**STAFF RECOMMENDATION**  
**2704 Oakland Avenue**  
**February 17, 2016**

**Application:** New construction – outbuilding; Setback determination  
**District:** Belmont-Hillsboro Neighborhood Conservation Zoning Overlay  
**Council District:** 18  
**Map and Parcel Number:** 11704016800  
**Applicant:** Van Pond, Architect  
**Project Lead:** Sean Alexander, sean.alexander@nashville.gov

1 Proposed Site Plan

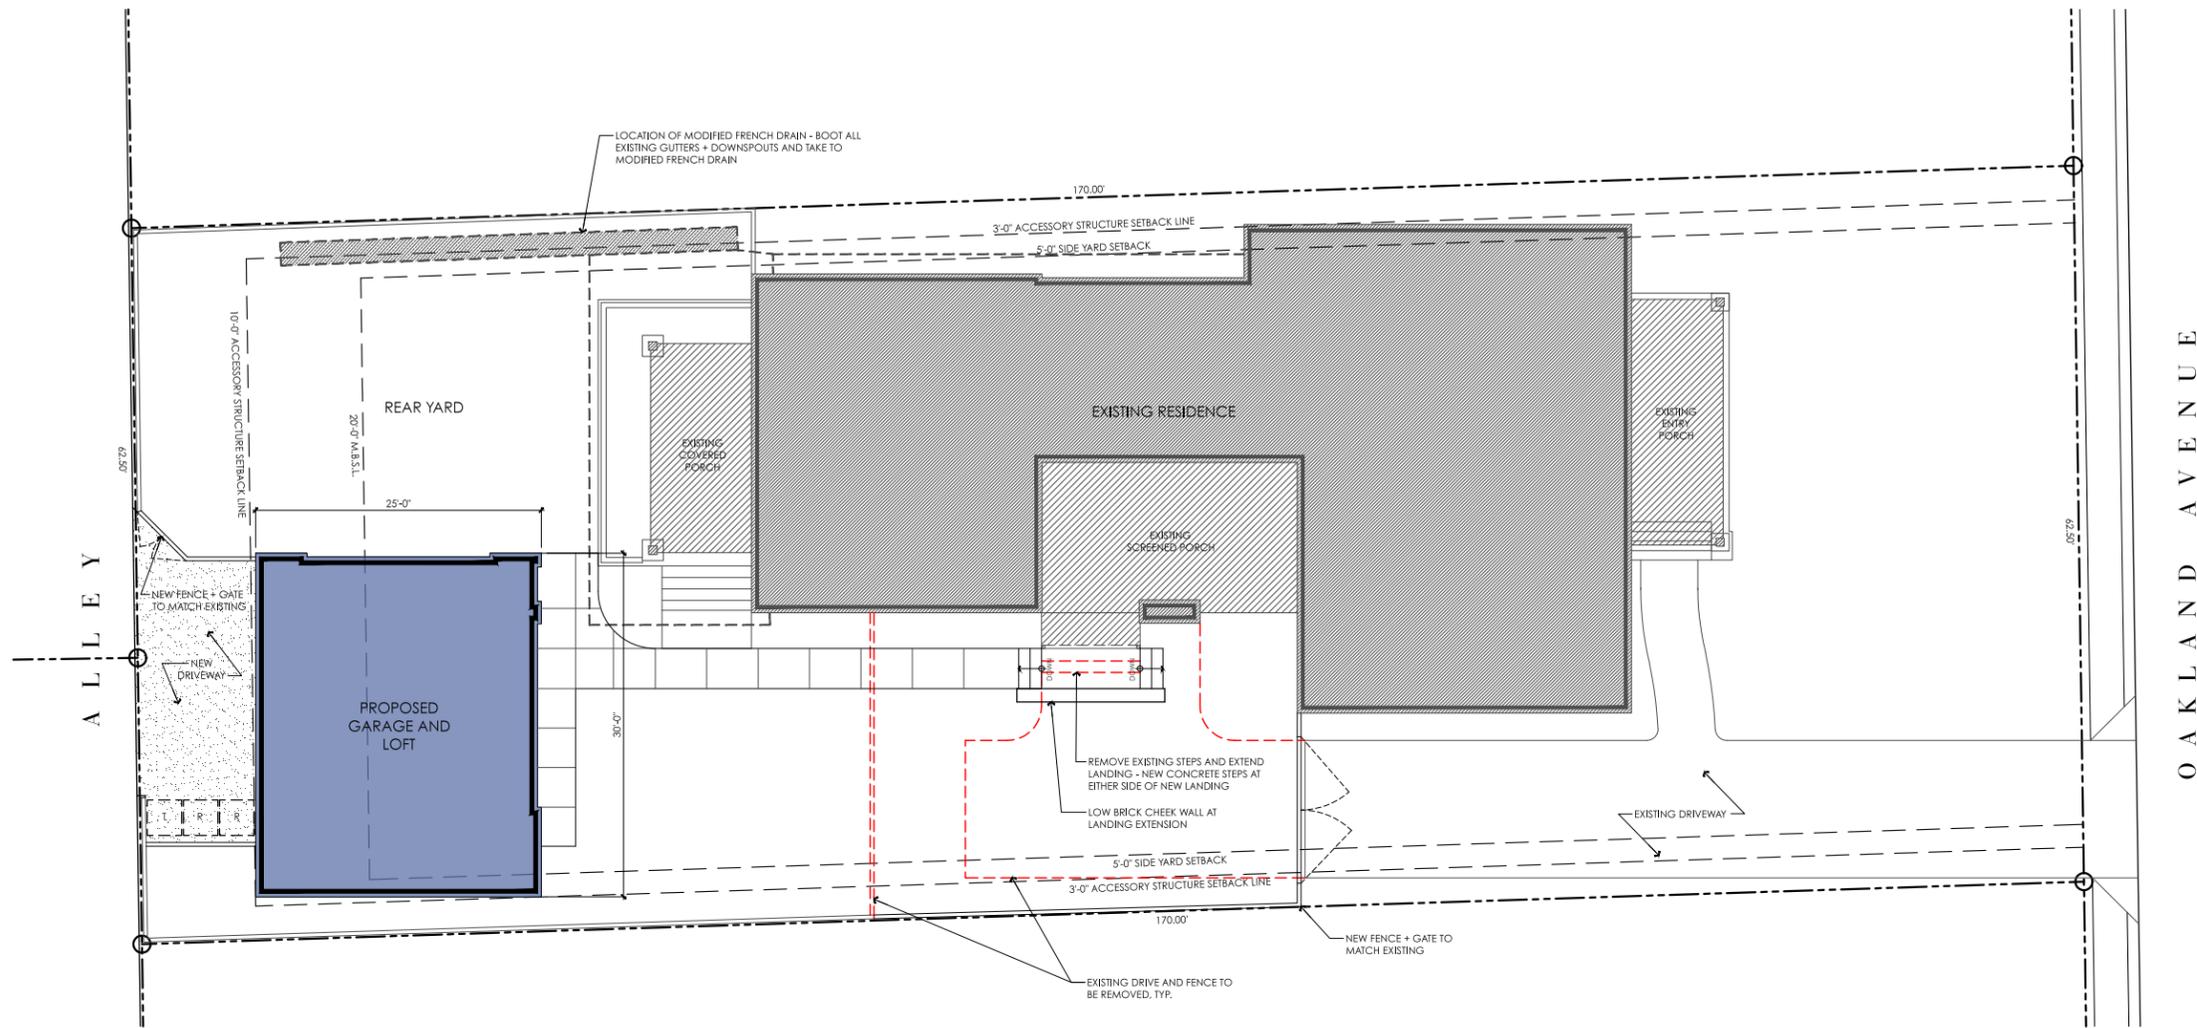
Setbacks: The outbuilding will be located behind the principal building at the rear of the lot, with a rear setback of ten feet (10'), a left side setback of three feet (3'), and a right side setback of twenty-nine feet (29'). The footprint of the building will be located ten feet (10') from the rear of the existing house. The required side setbacks for an outbuilding with a footprint greater than seven hundred square feet (700 sf) is twenty feet (20') for the rear and five feet (5') for the sides, and the design guidelines require outbuildings to be separated from a principal building by twenty feet (20'). However, Staff finds the proposed outbuilding location to be appropriate because it would be in keeping with the typical location of historic outbuildings. The ten foot (10') separation is appropriate because there is not another location for the building and pushing it closer to the rear property line would likely create turn-radius issues. Staff finds the setbacks of the proposed outbuilding to meet section II.B.1.c of the design guidelines.

③ Proposed Garage Roof Plan

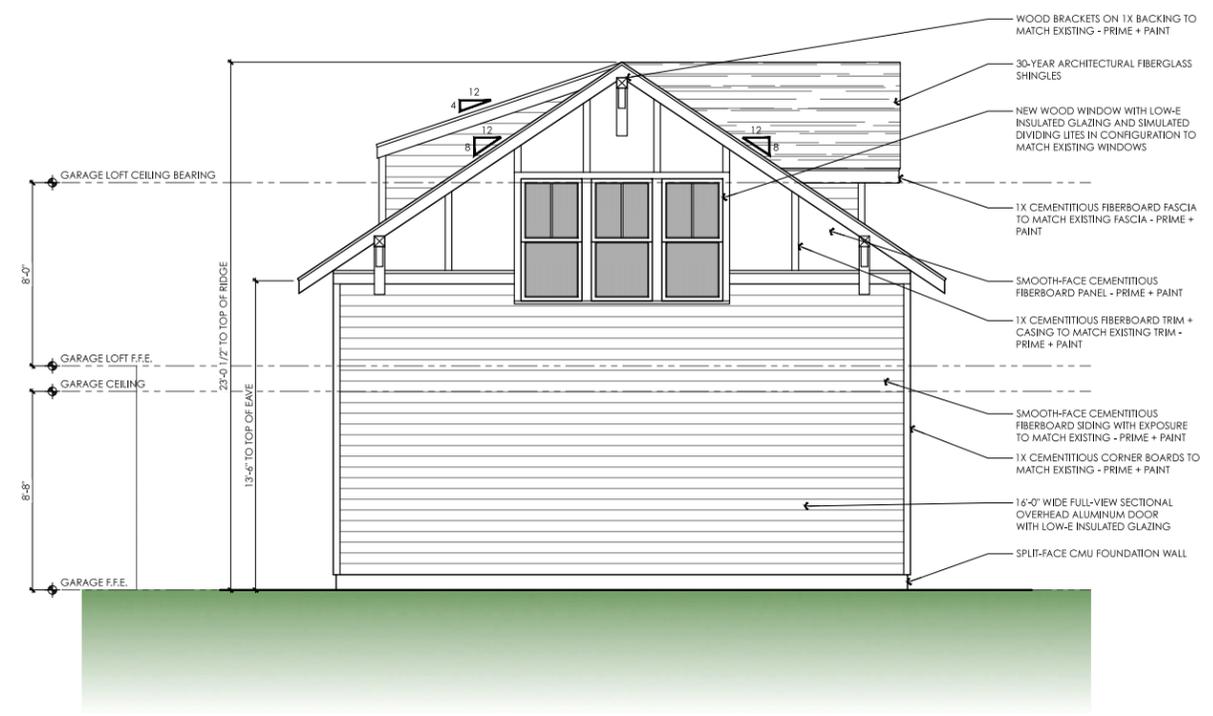
Roof form: The primary roof of the outbuilding will be a side-oriented gable with a pitch of 8:12, matching the roof of the house. There will be a gabled dormer on the front slope of the roof with an 8:12 pitch, with a 4:12 pitched shed roofed dormer on the rear slope. Both dormers will sit back two feet (2') from the first story walls of the building. Staff finds the roofs of the proposed outbuilding to be compatible with those of the principal building and to meet section II.B.1.e of the design guidelines.

Note: The gabled dormer will be ten feet wide or approximately one-third (1/3) of the width of the roof, and the shed dormer will be twenty-two feet (22') wide or approximately two-thirds (2/3) the width of the roof. Although the outbuilding is not proposed to be a detached accessory dwelling unit, with the rear dormer greater than one-half (1/2) the width of the roof the outbuilding would not meet the standards for a DADU under Section 17.16.030 of the Metro Code.

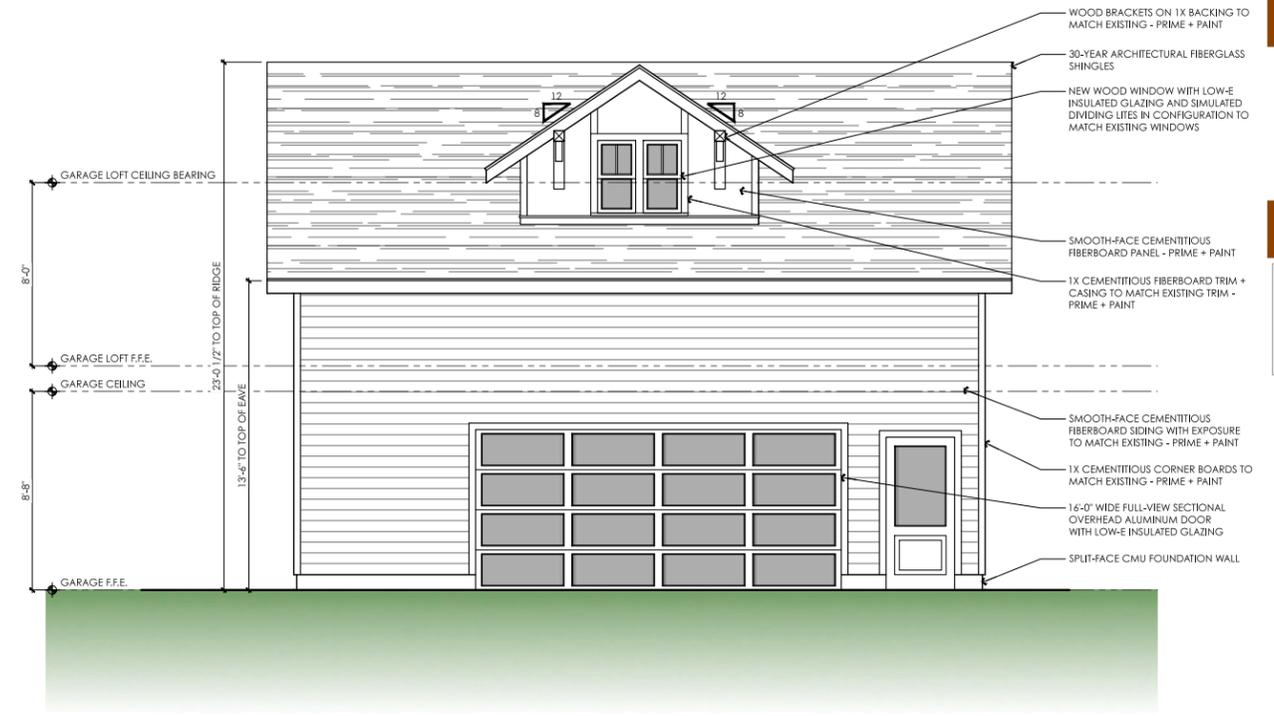
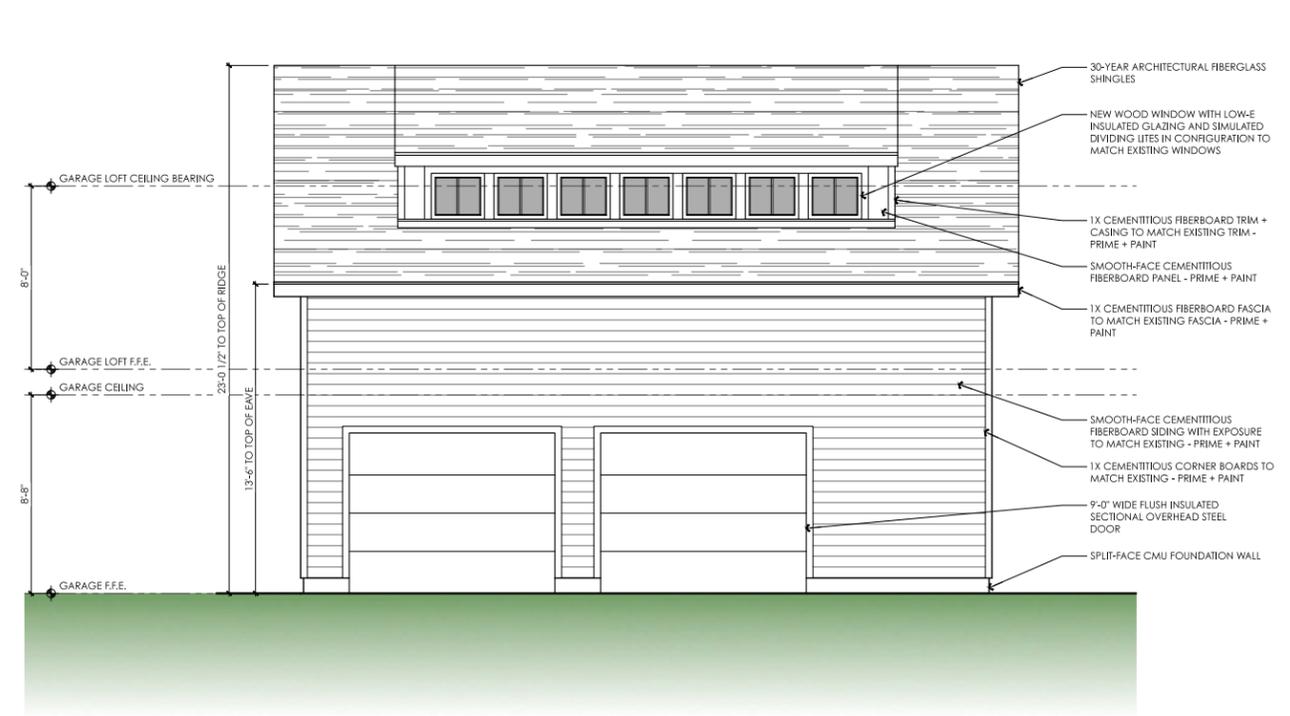
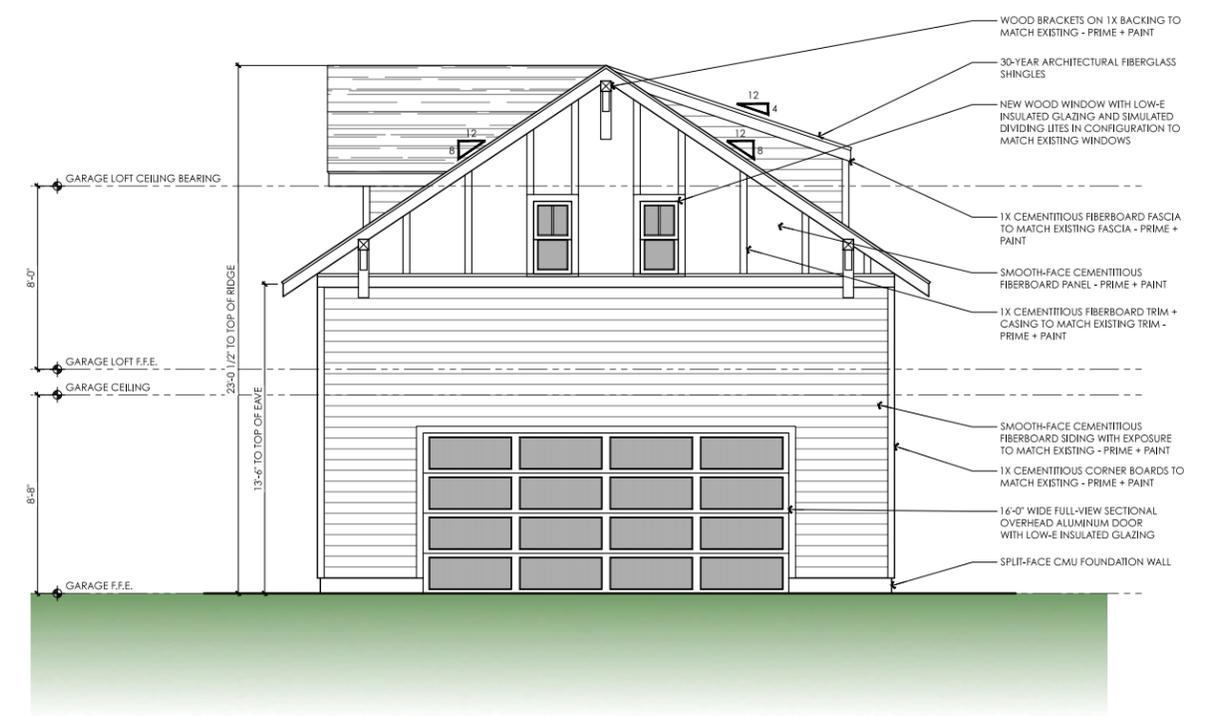
**Height & Scale:** The roof height of the proposed outbuilding, averaged from the grade at its corners, would be twenty-three feet (23’) and the eave height would be thirteen feet (13’). The ridge height for the historic house, averaged from the grade at its corners, is twenty-three feet (23’) with an eave height of twelve feet (12’). Because the grade is approximately one foot (1’) lower at the rear of the lot where the outbuilding is to be located, in elevation the eaves of the outbuilding would be aligned with those of the house. However, the design guidelines consider outbuilding heights in proportion to the principal building irrespective of grade; just as outbuildings located on higher ground would not be required to be proportionally shorter, outbuildings on lower ground may not be taller. Furthermore, the guidelines state that the ridge and eave heights of outbuildings should not exceed the corresponding heights of an historic house, up to a maximum of ten feet (10’) for eaves and twenty-five feet (25’) for ridge height. Staff finds the height of the eaves on the proposed outbuilding to be inappropriate and to not meet the design guidelines.

Staff recommends that the eave height of the building be reduced to ten feet (10') to meet sections II.B.1.a, II.B.1.b, and II.B.1.i of the design guidelines.

Note: Although the outbuilding is not proposed as a detached accessory dwelling unit, the floorplans depict a future bathroom and kitchen which may be added later. With eaves greater than ten feet (10') in height, the outbuilding would not meet the standards for a DADU under Section 17.16.030 of the Metro Code.

- The eave heights shall be reduced to ten feet (10');
- The garage door facing the street shall be one bay wide or shall be two single bays; and
- The window and door selections are approved by MHZC Staff prior to purchase and installation.
